RESPONSES TO
NRC QUESTIONS
ON THE
MONTICELLO PUAR

PREPARED BY
NUTECH ENGINEERS, INC.
SAN JOSE, CALIFORNIA

PREPARED FOR
NORTHERN STATES POWER CO.

NRC QUESTION ON MONTICELLO PUAR
HYDRODYNAMIC LOAD RESPONSE

Figure 18 - 6" ϕ

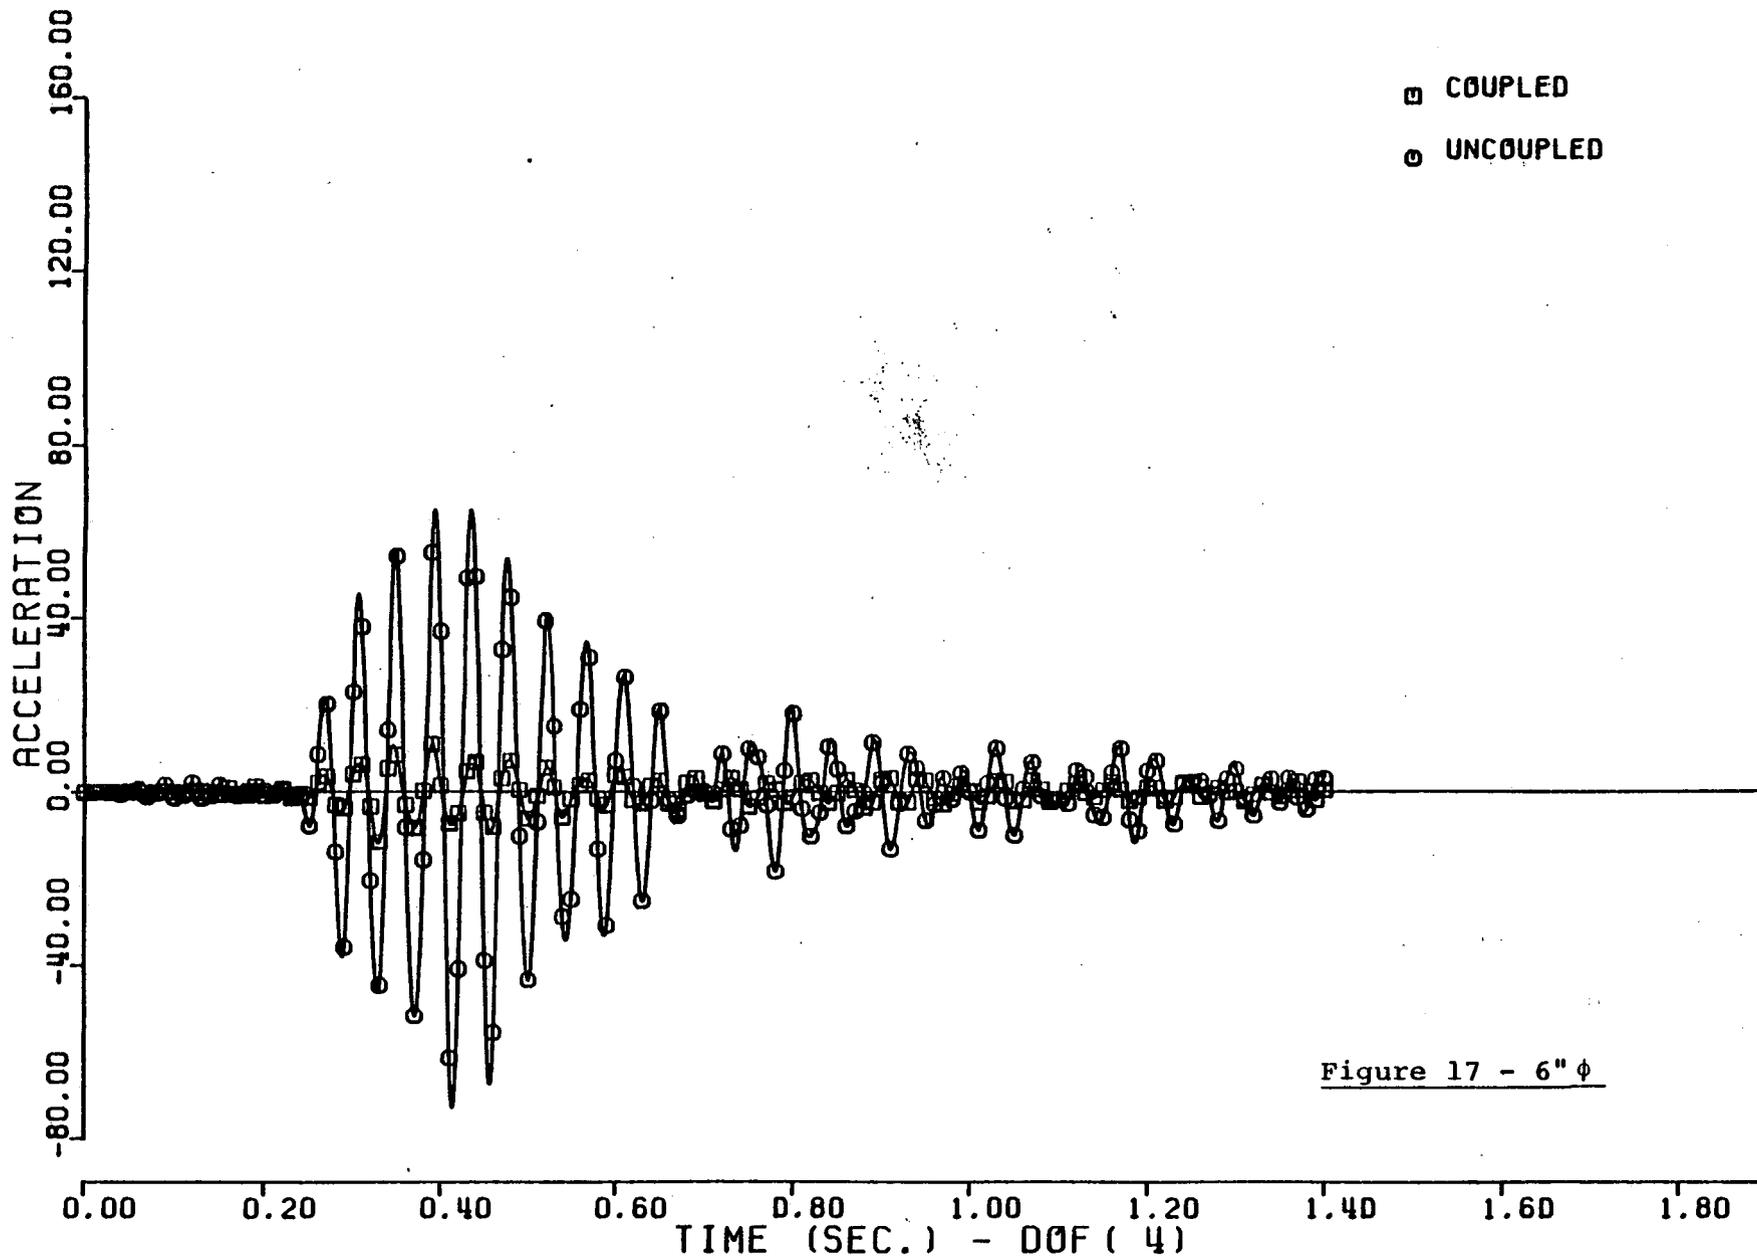
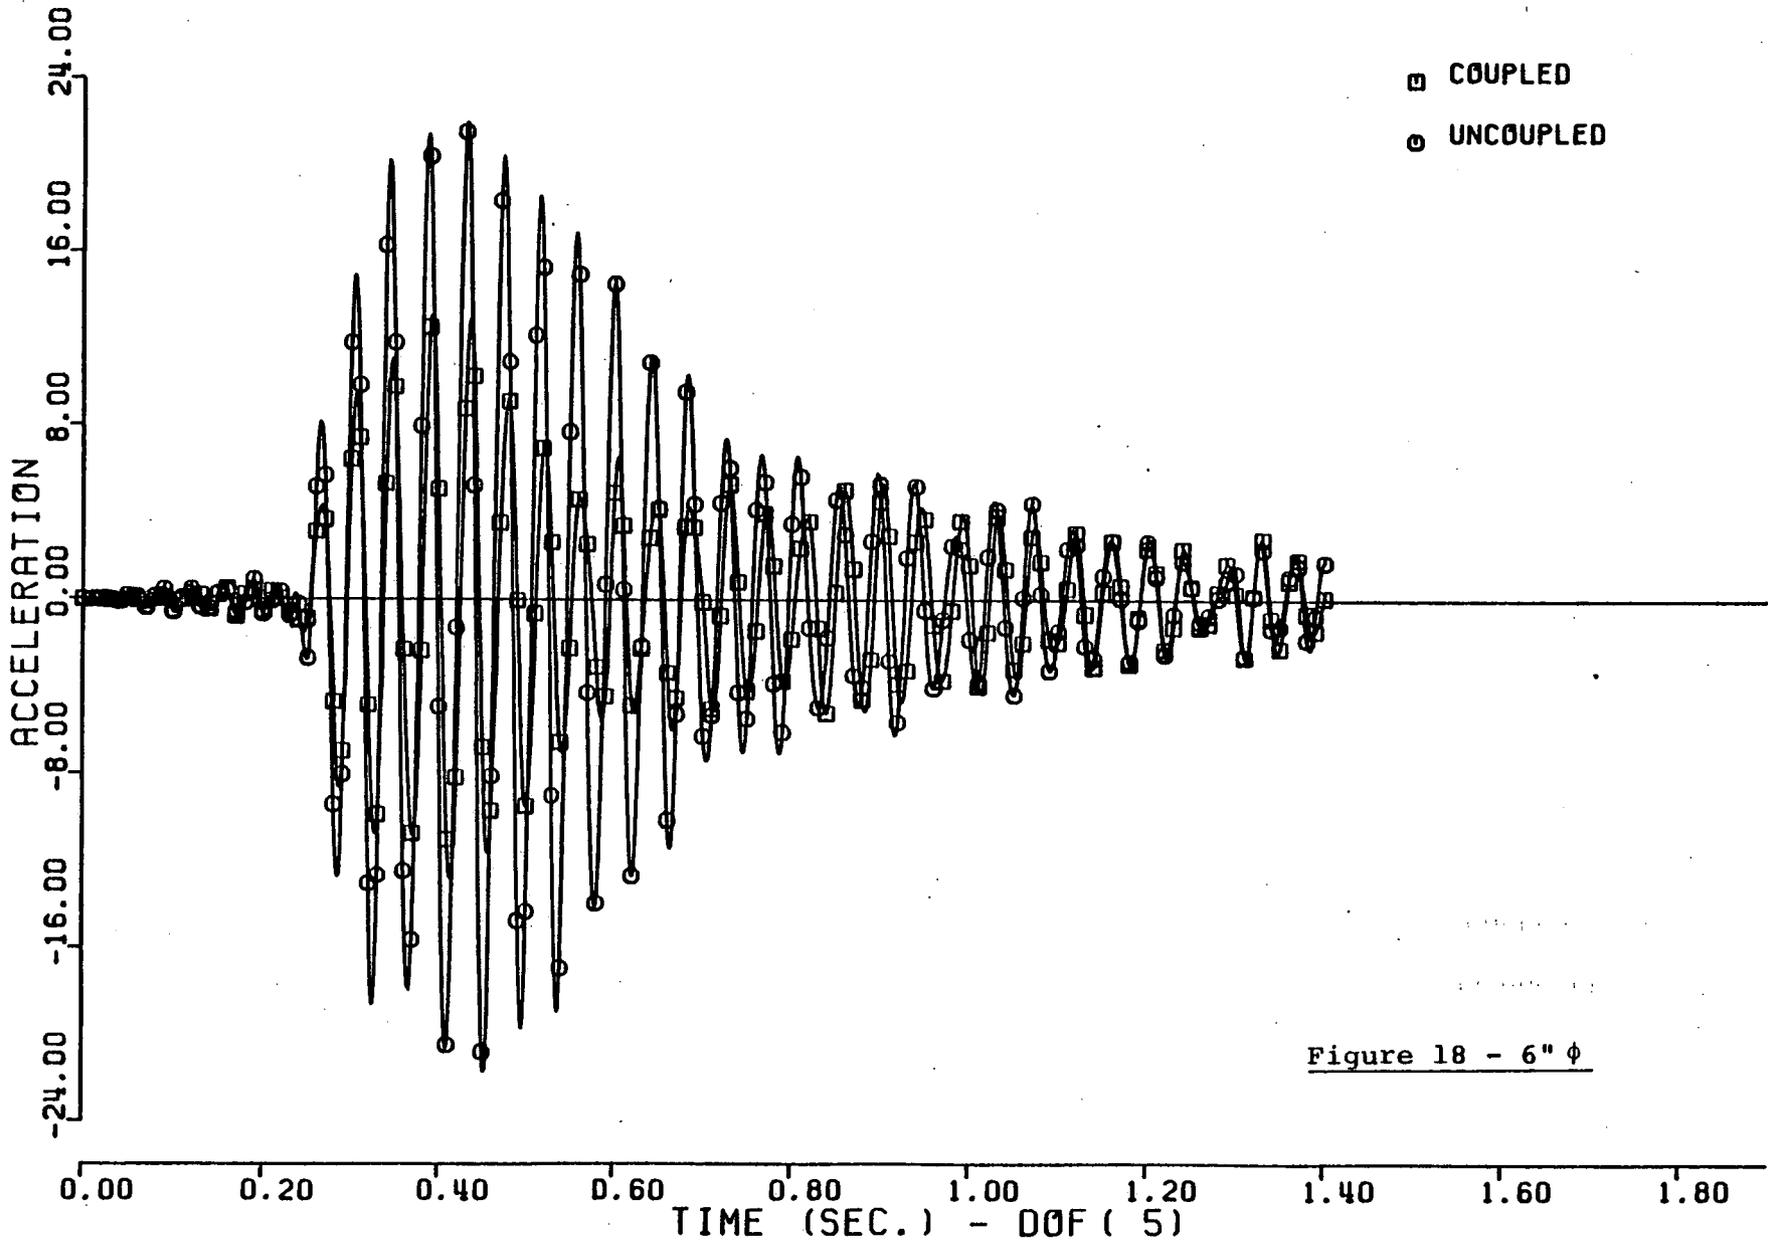
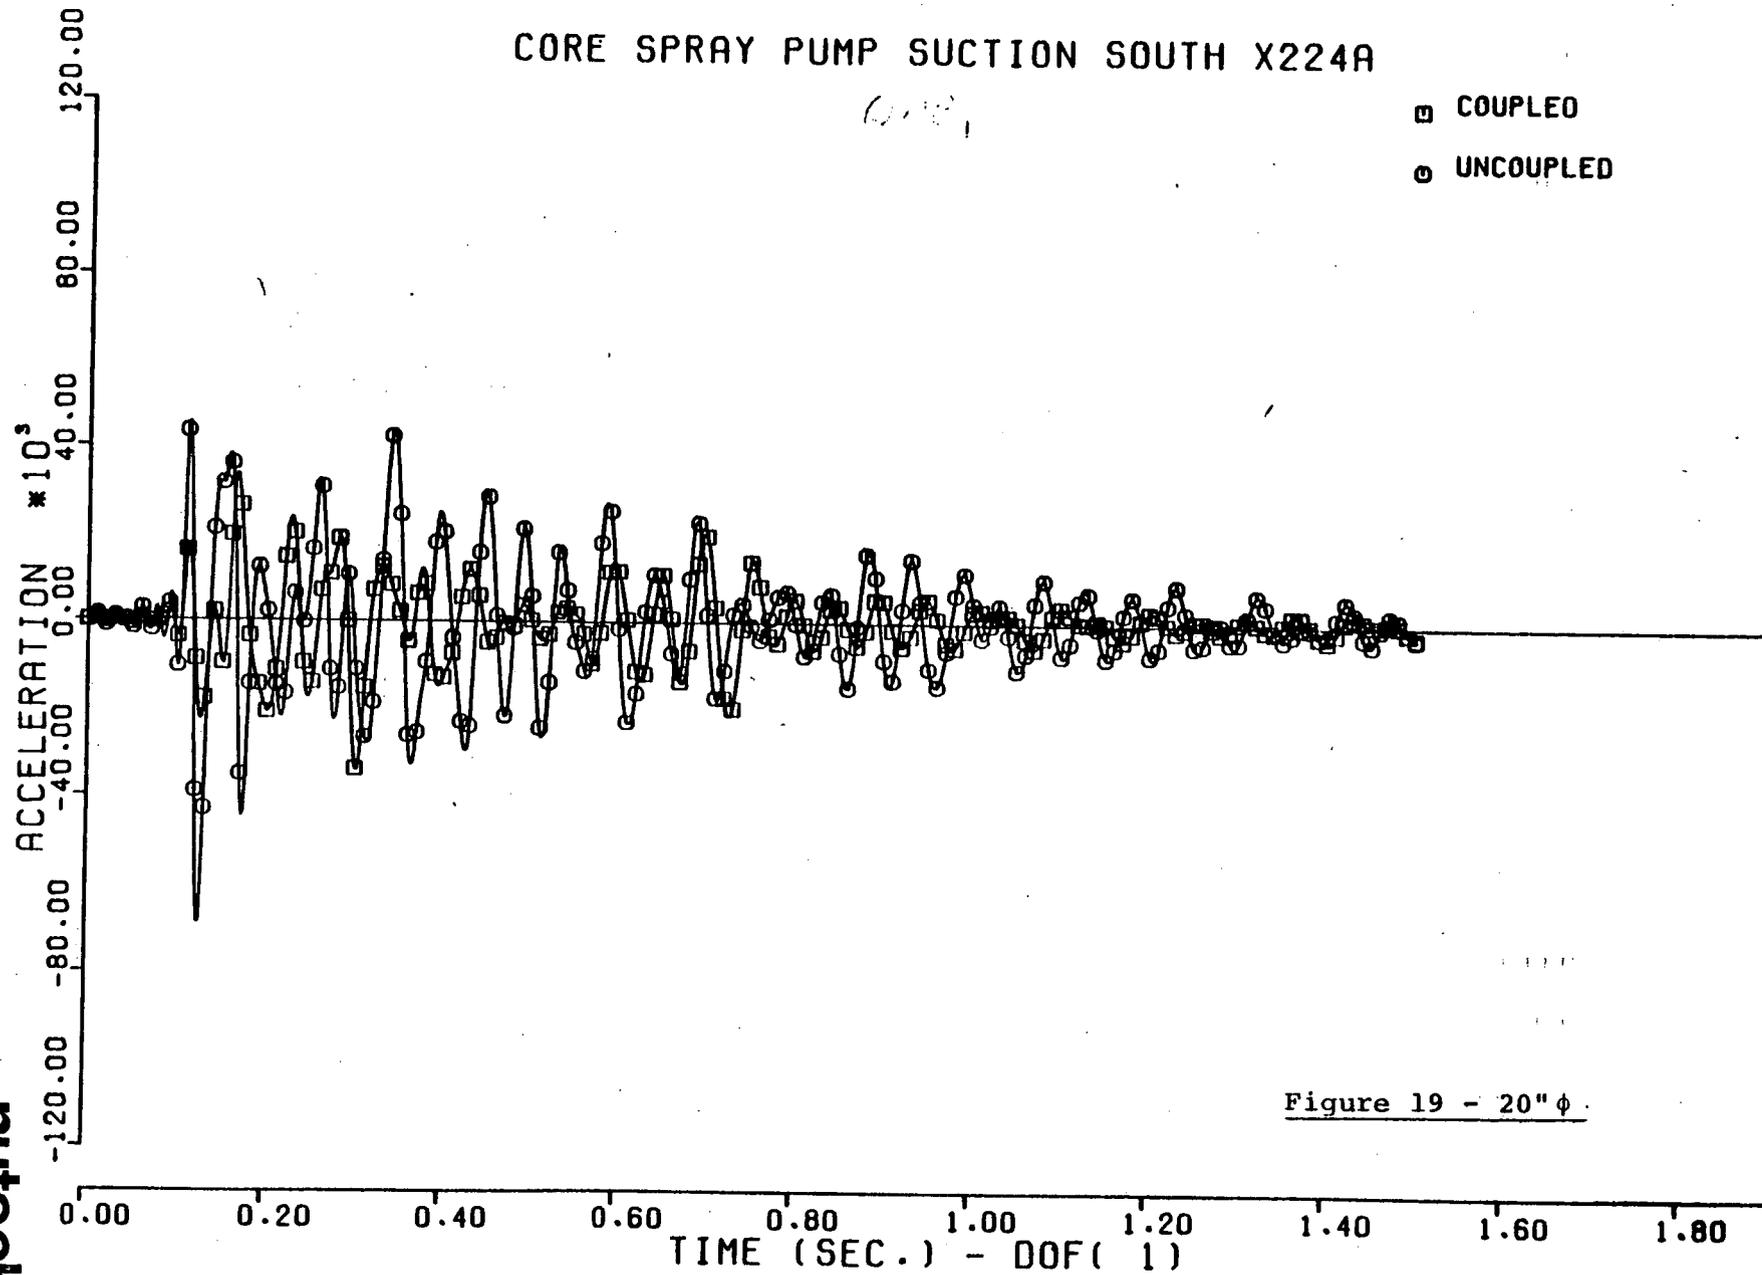
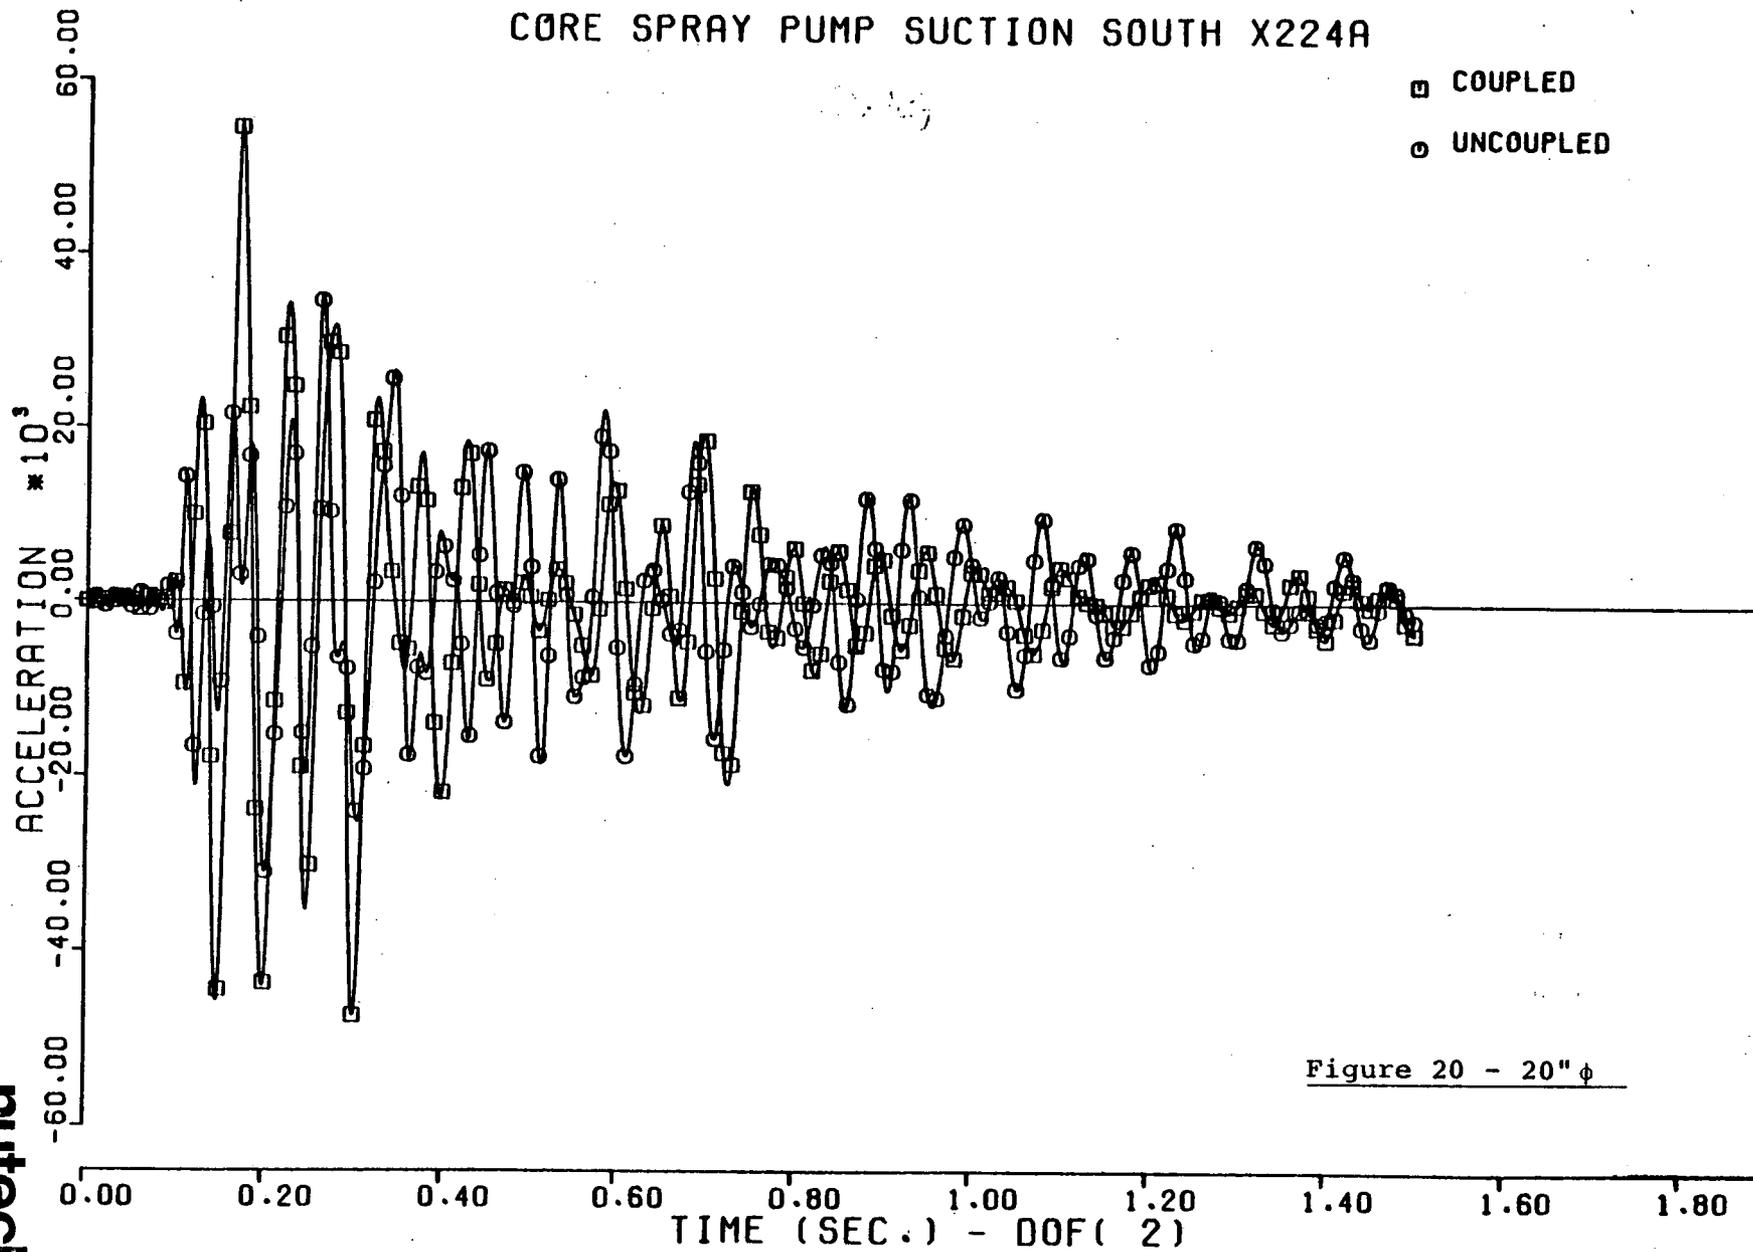
ITEM 12: The computer code CMDOF has been used in the torus attached piping analysis for all plants that utilized NUTECH as their contractor. With regard to the code provide the following information:

- 1) Theoretical background of CMDOF computer program
- 2) Program verification
- 3) Applicability of the computer program to the torus attached piping analysis.

To illustrate the effect of pipe size on coupling, four typical piping systems were examined and the coupled and uncoupled time histories plotted together. These time histories include both the smallest (2") and larger (20") systems analyzed. Listed below are the figure numbers and the corresponding line size.

Figure 4-8	2" diameter
9-13	4" diameter
14-18	6" diameter
19-21	20" diameter

These plots confirm the expected variation of coupling benefit with pipe size.
